REGIONAL REVIEW NOTIFICATION

ARC REVIEW CODE: R1712061

Name of Proposal: The Interlock (DRI 2747)
Review Type: Development of Regional Impact (DRI)
Submitting Local Government: City of Atlanta
Date Opened: December 6, 2017
Deadline for Comments: December 21, 2017 by 5:00 PM
Date to Close: December 26, 2017

TECH WEST/THE INTERLOCK DRI
City of Atlanta
Natural Resources Division Review Comments

DRI Site Plan

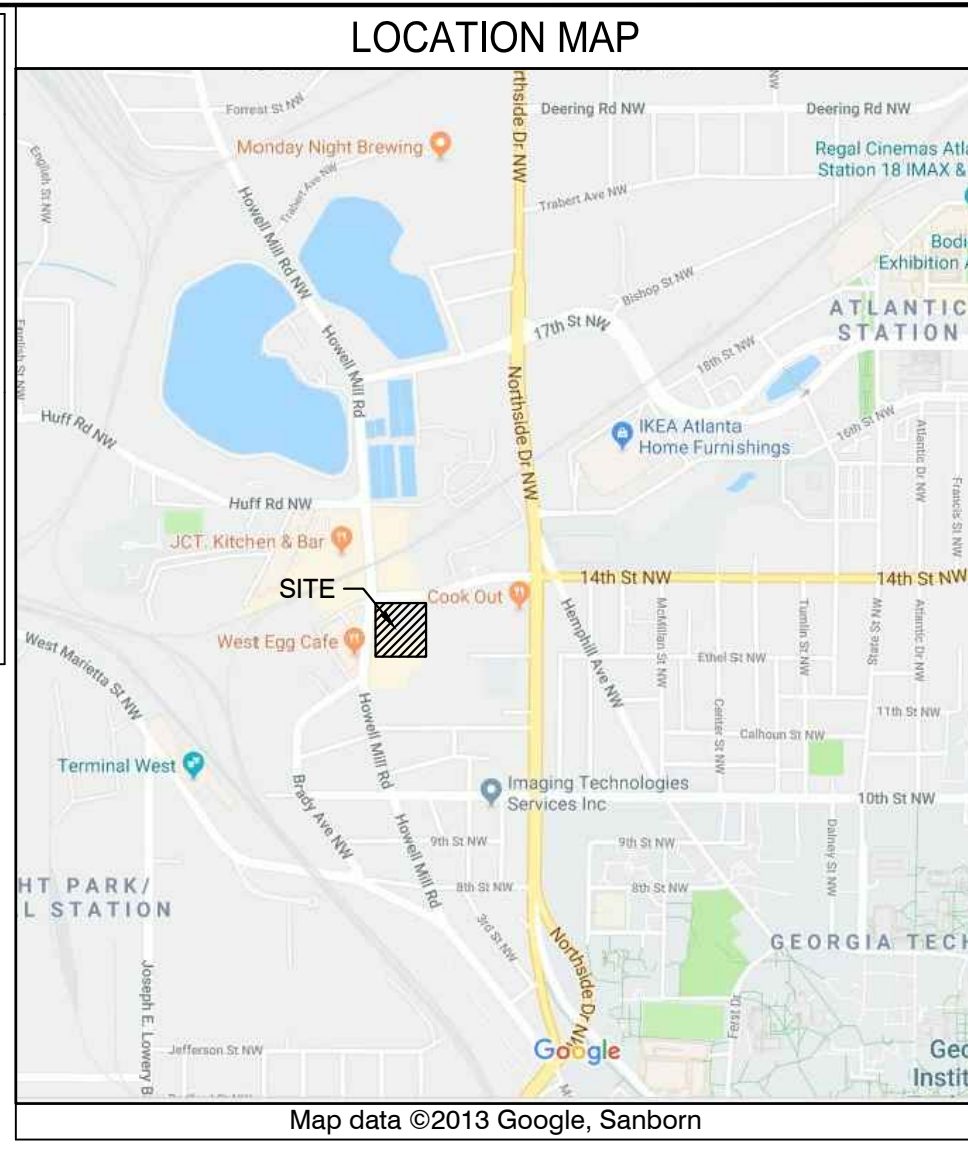
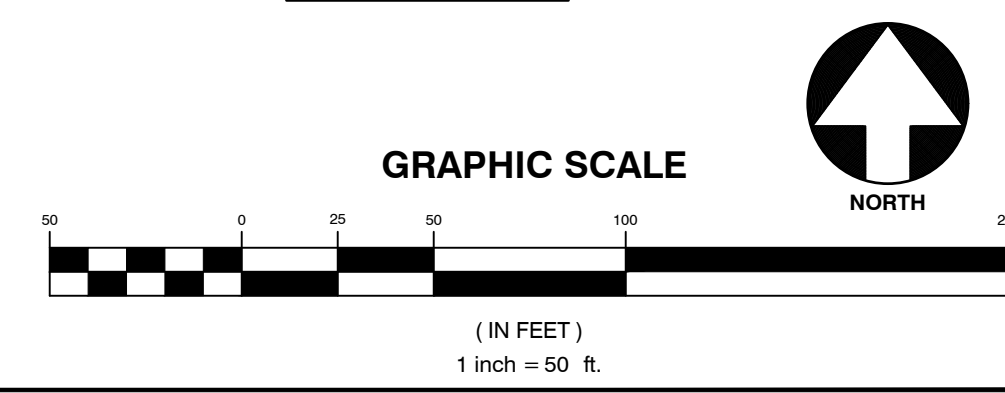
The site depicts existing pedestrian facilities along Howell Mill Road, and along segments of 14th street and along Ethel Street west of Northside Drive. The site plan also depicts provisions for internal pedestrian facilities to the site.
